# LOT 10 PARKER POINTE

LOT 10, PARKER POINTE FILING NO. 1  
 A PART SECTION 3, TOWNSHIP 7 SOUTH, RANGE 66 WEST OF THE SIXTH PRINCIPAL MERIDIAN  
 TOWN OF PARKER, COUNTY OF DOUGLAS, STATE OF COLORADO

## SITE PLAN

## LANDSCAPE PLAN

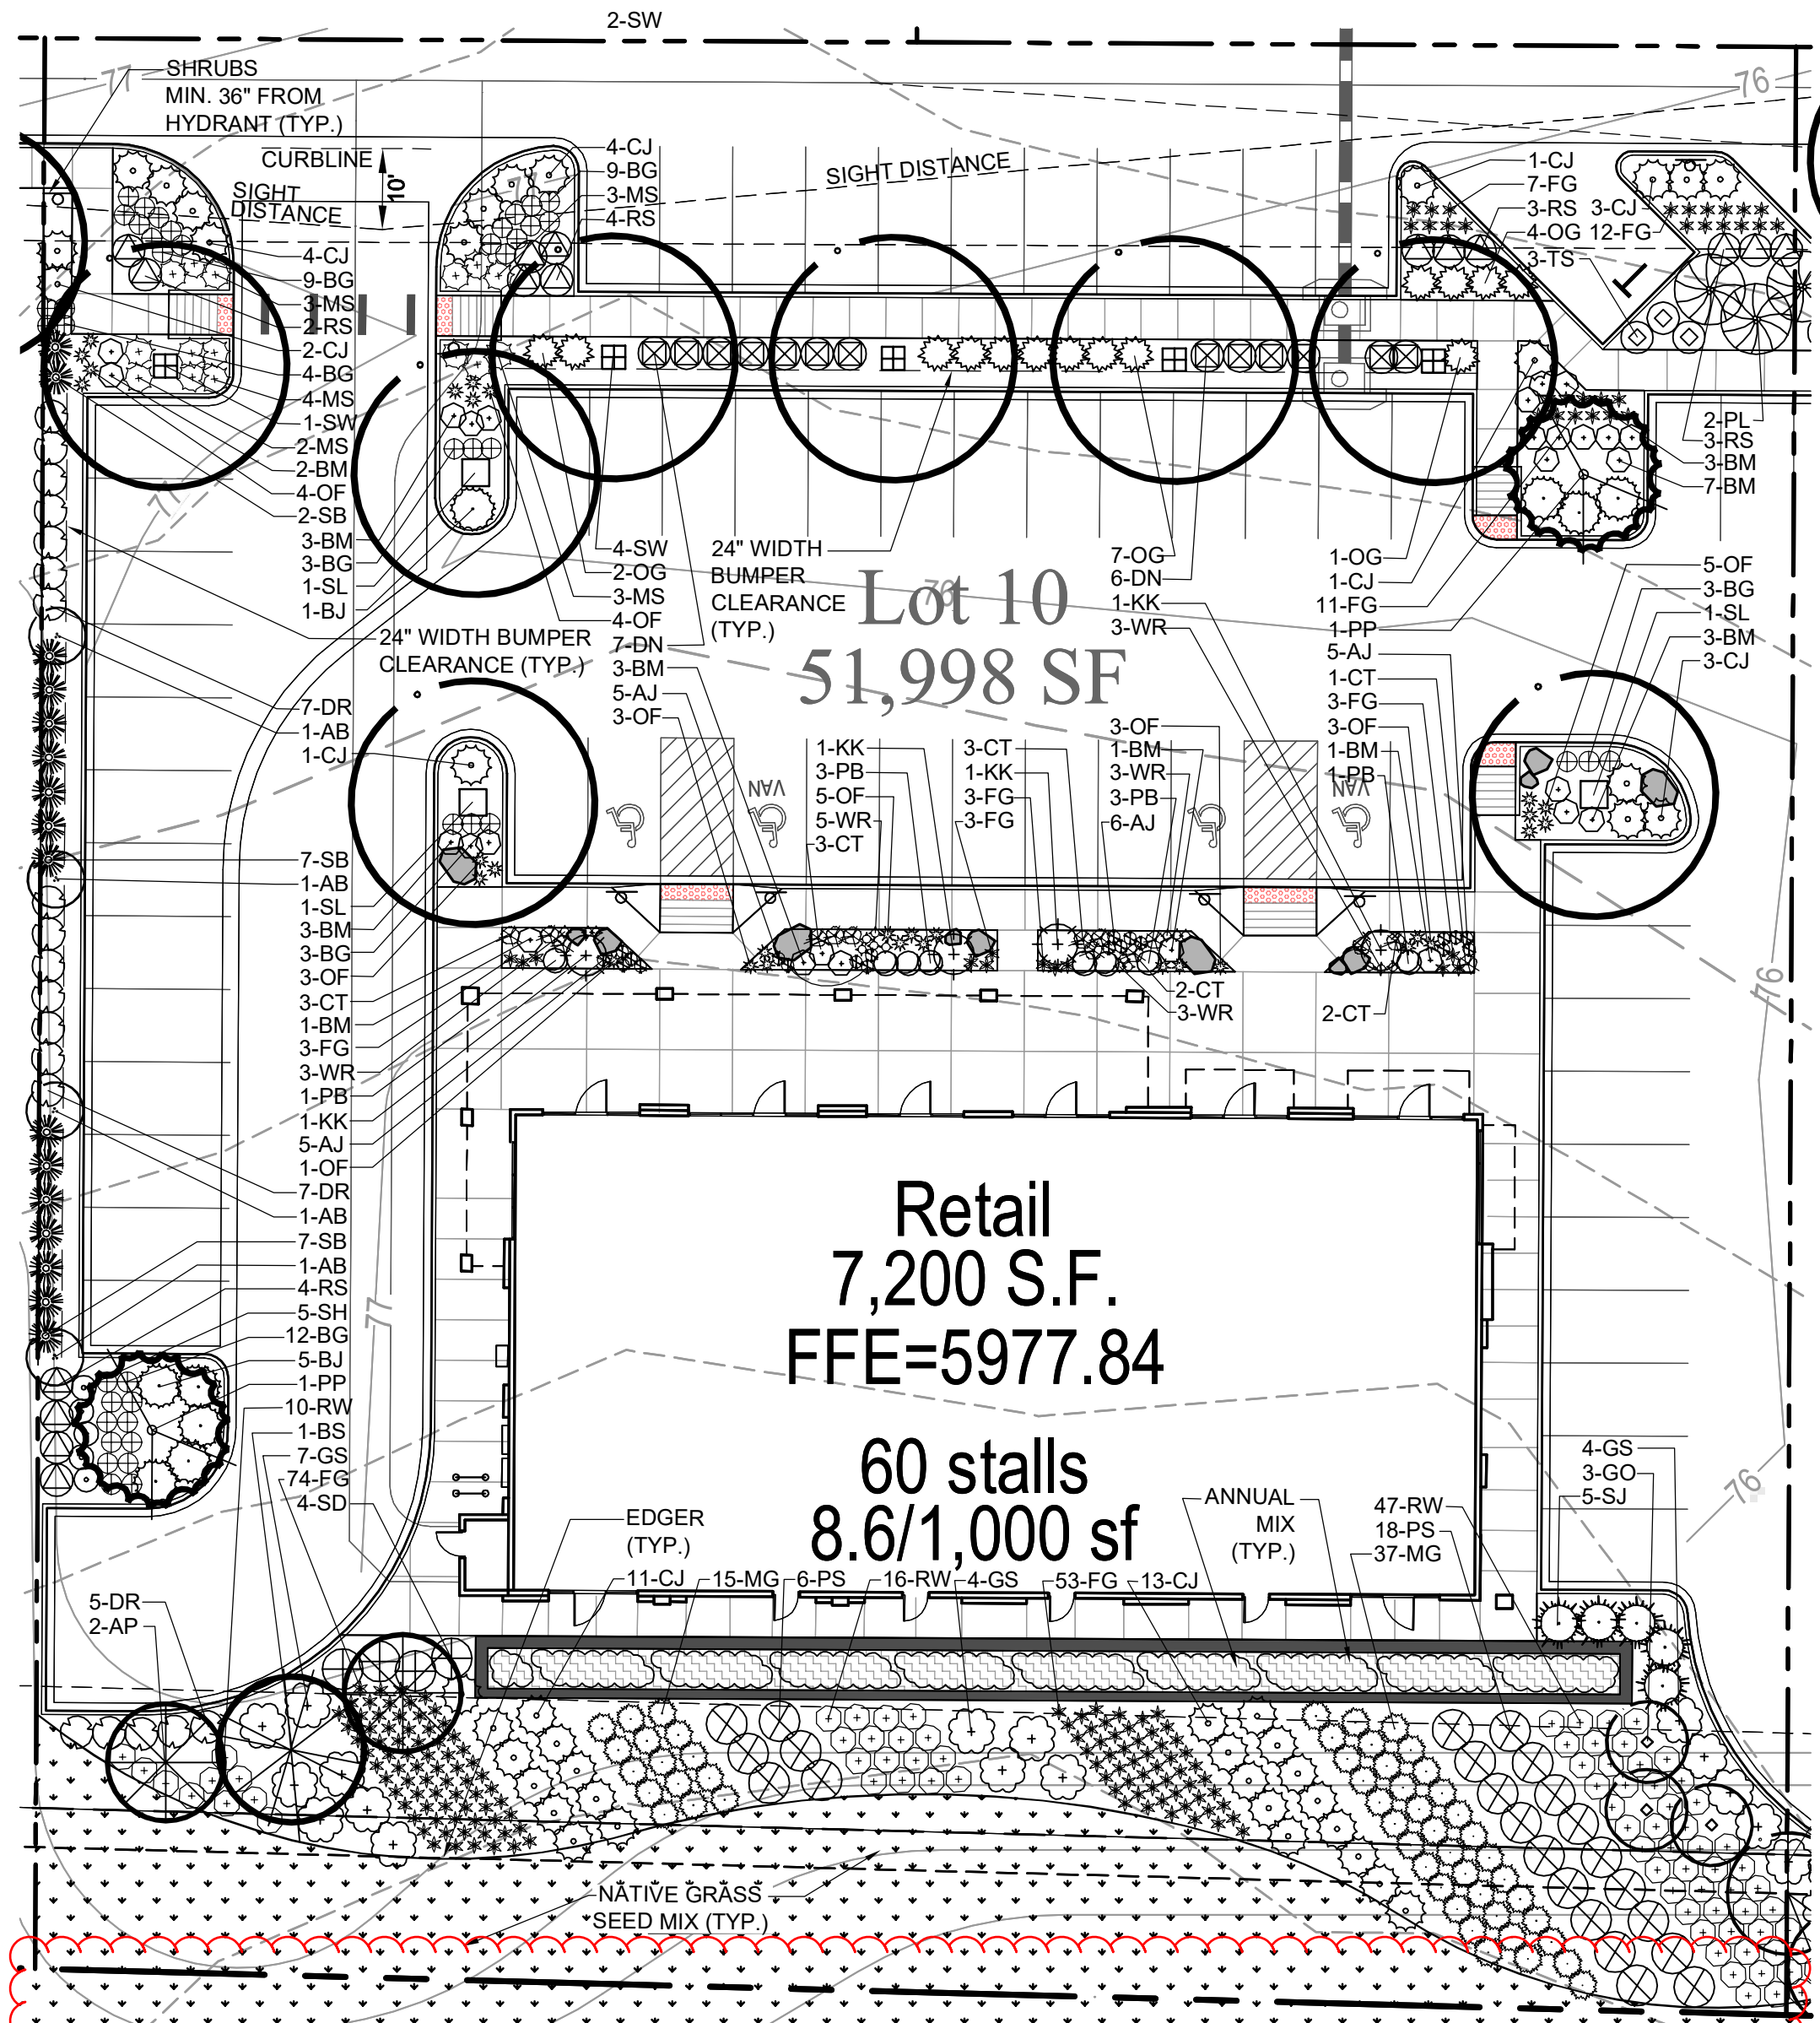
Perimeter landscape is in addition to streetscape required on the east property boundary. Please revise to include perimeter landscaping for the eastern edge.

Landscaping within ROW may not be counted toward on site landscape requirements. Please verify that this area has not been included in calculations and provide a note that states such.

This signature block is not needed for the landscape plan as part of the site plan. Site Plans are administratively approved. This signature may be required as part of the CD's but should be removed from the site plan set.

## EXTERIOR ELEVATIONS

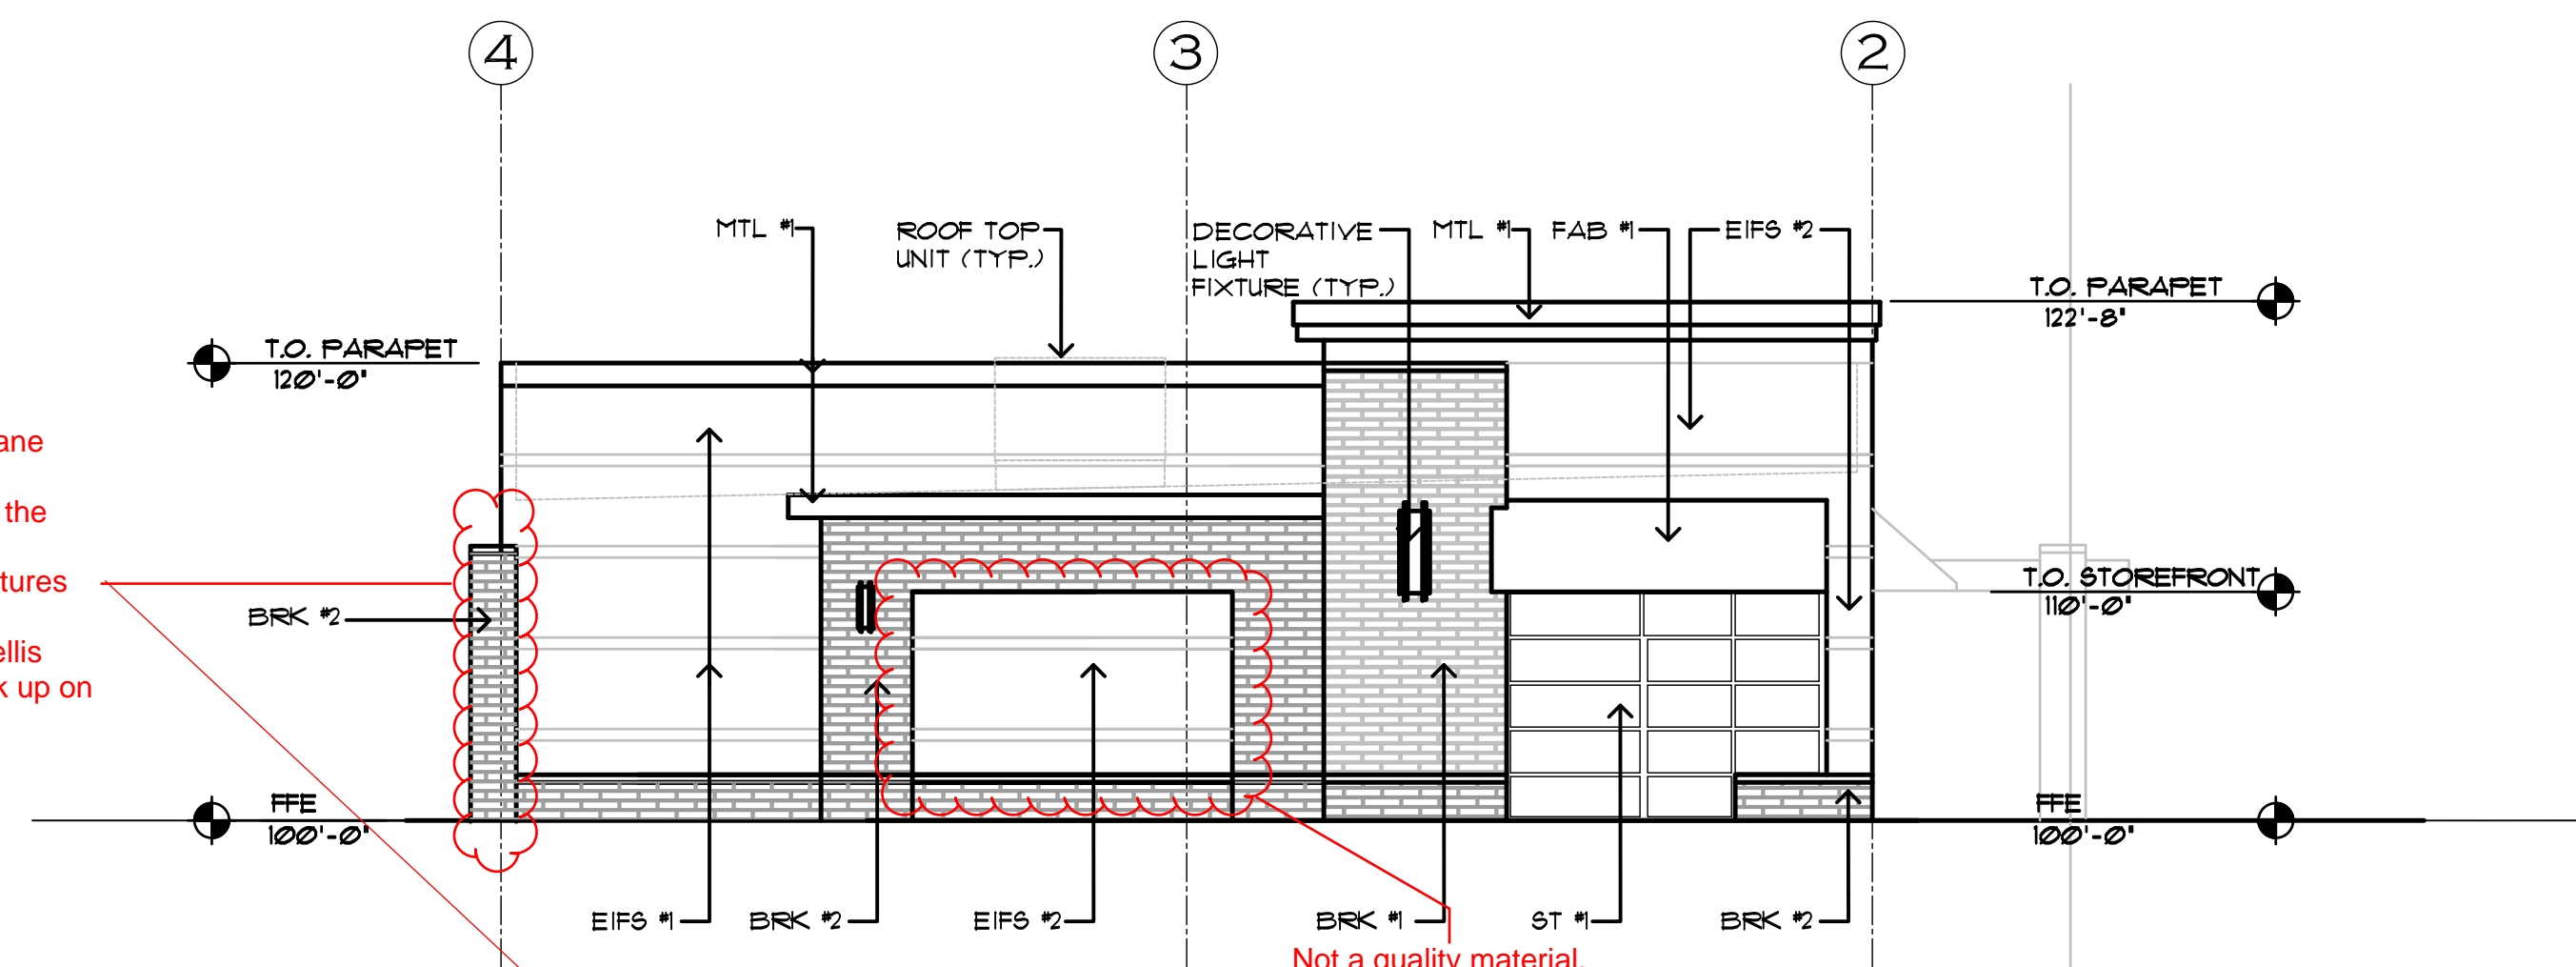
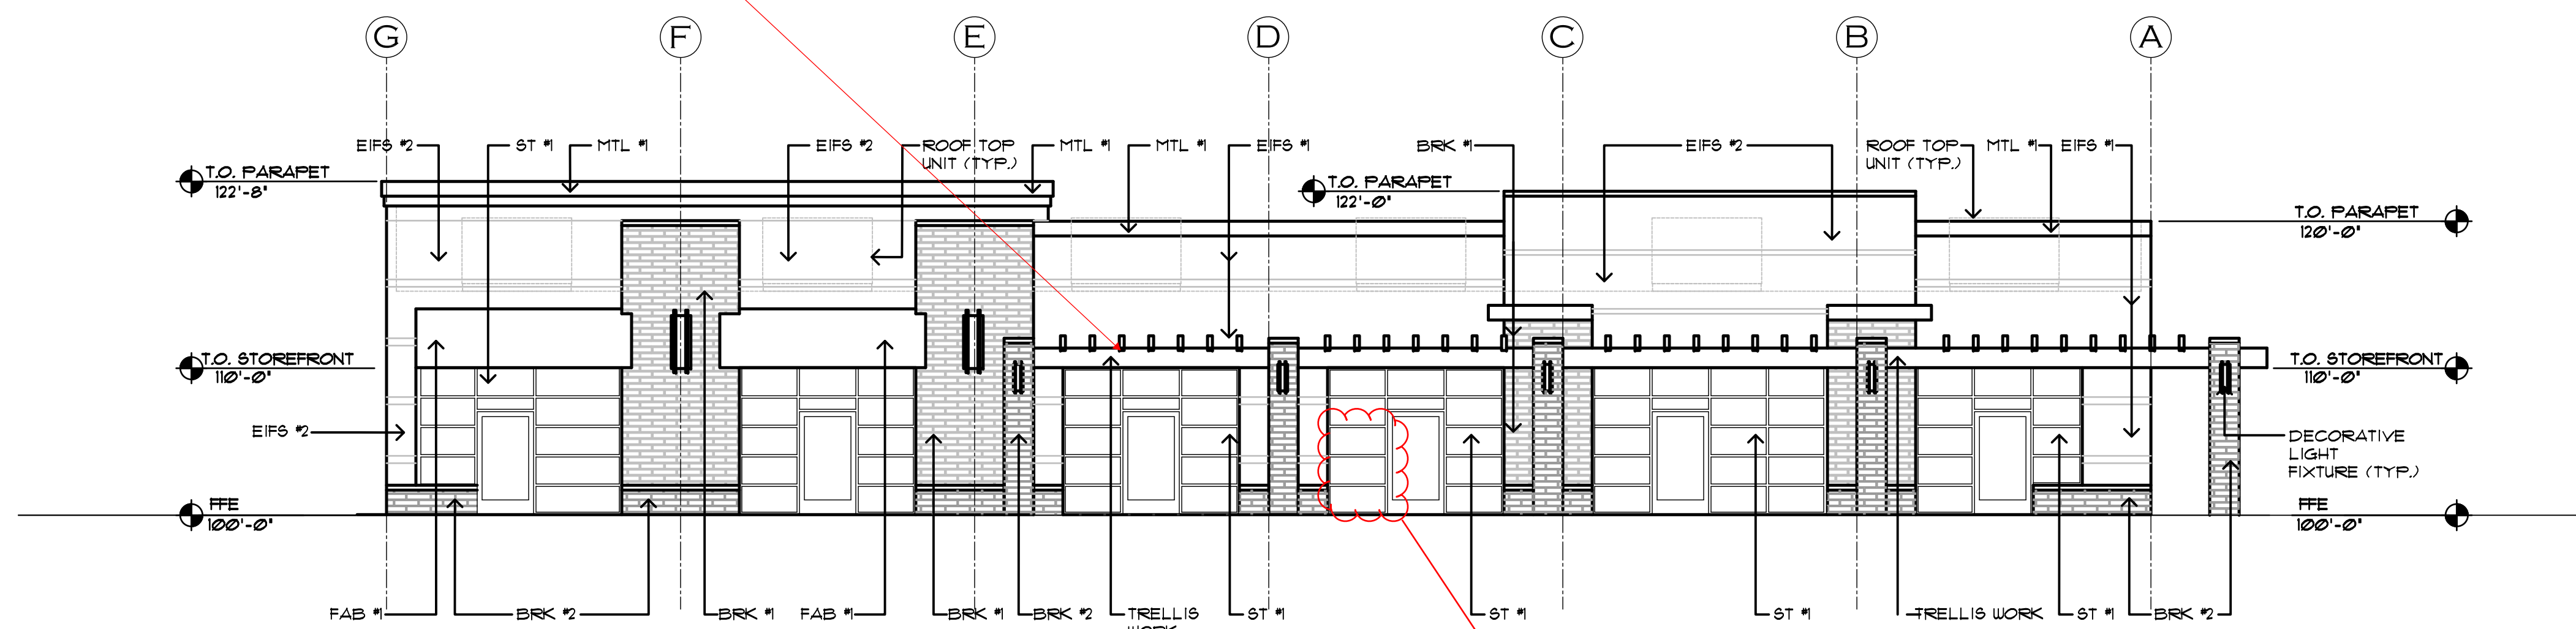
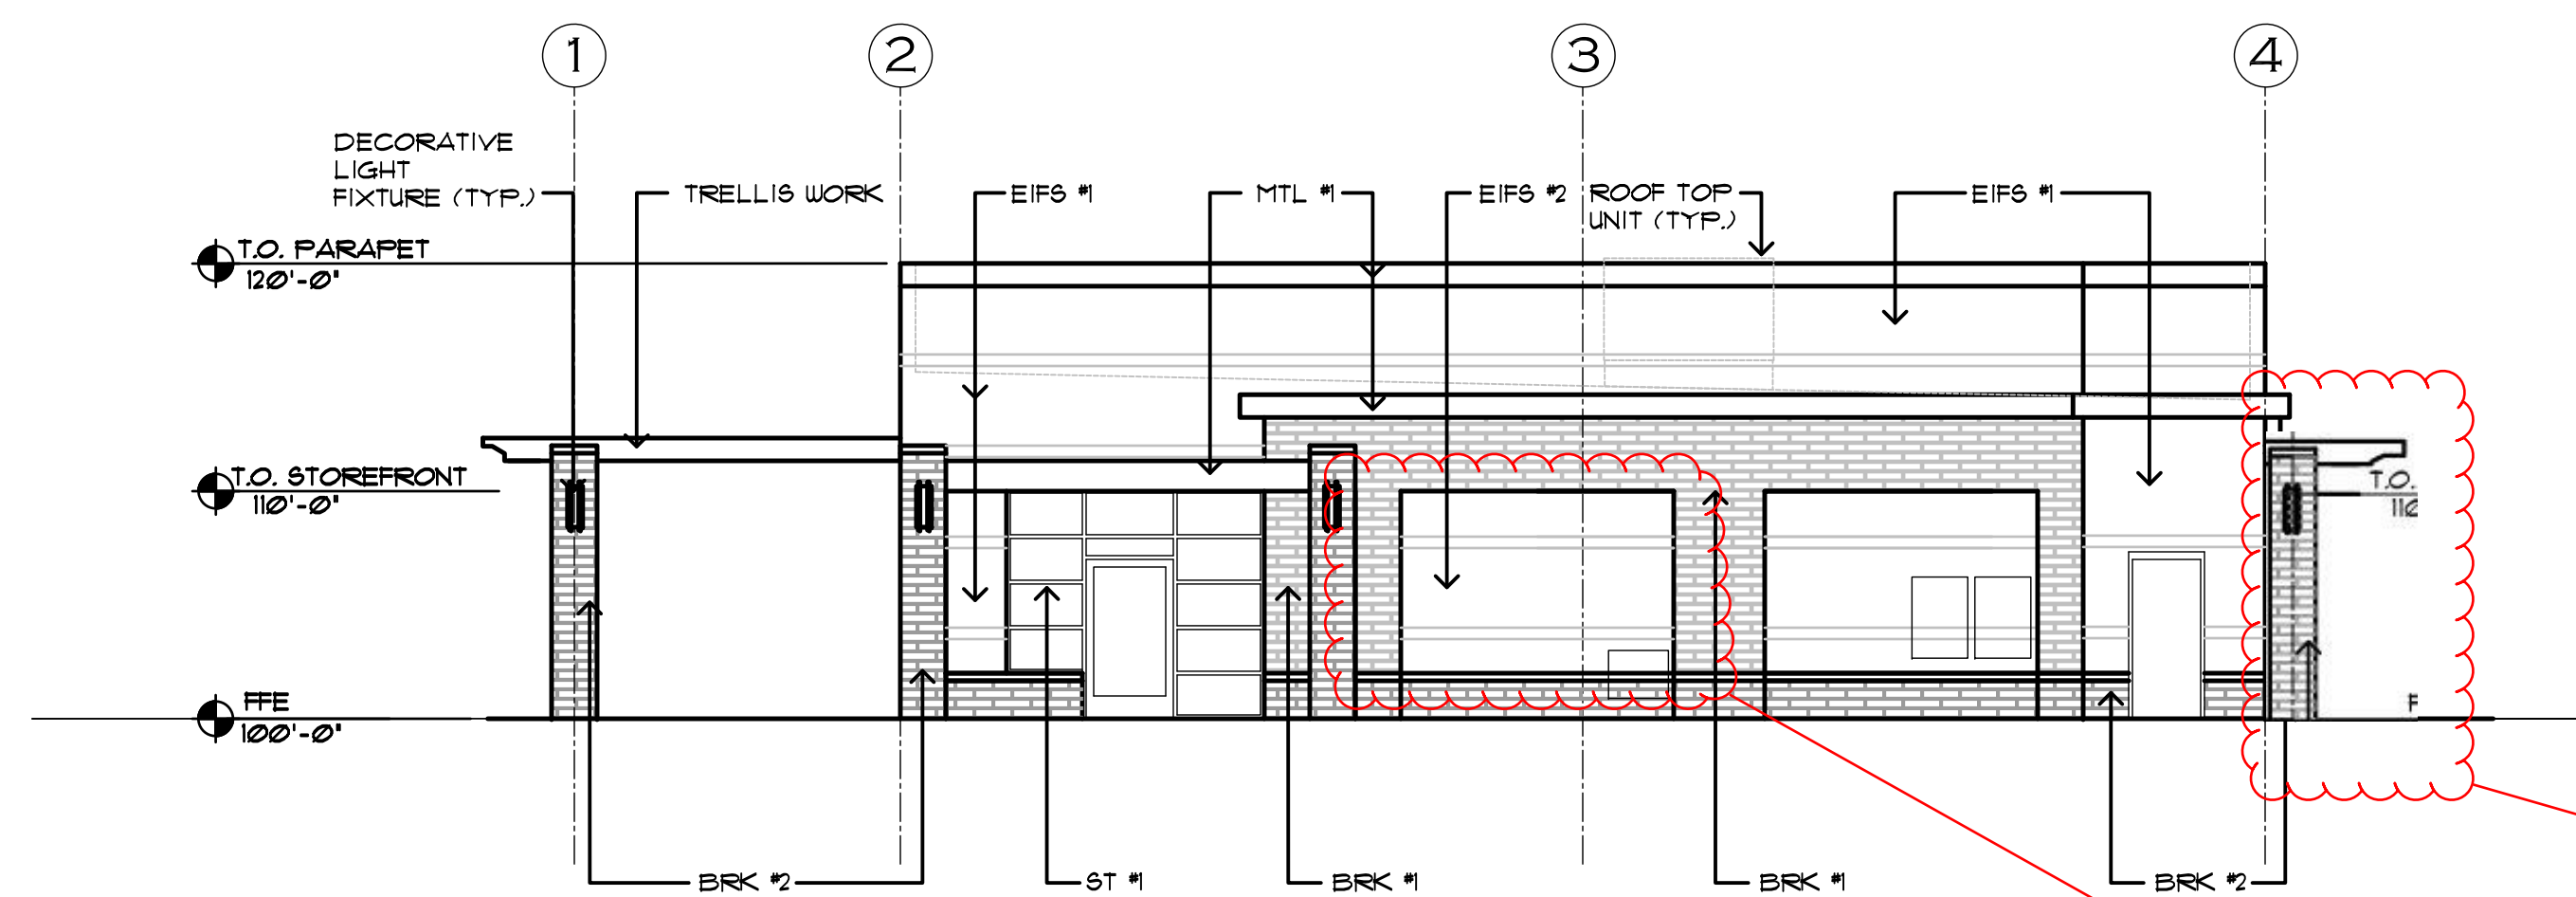
Need detail of planter box shown on west elevation.

Please call out all transparency on building and add to material table.

Need detail of cornice

Need detail of trellis. Also material proposed, not shown in materials table. Need a physical material sample of trellis material.

Need greater plane change. West elevation needs the addition of architectural features similar to east elevation, i.e. trellis detail. See mock up on 9 of 12.

Not a quality material. Consider other decorative treatment, base colored brick for instance.

Please clarify, transparent material?
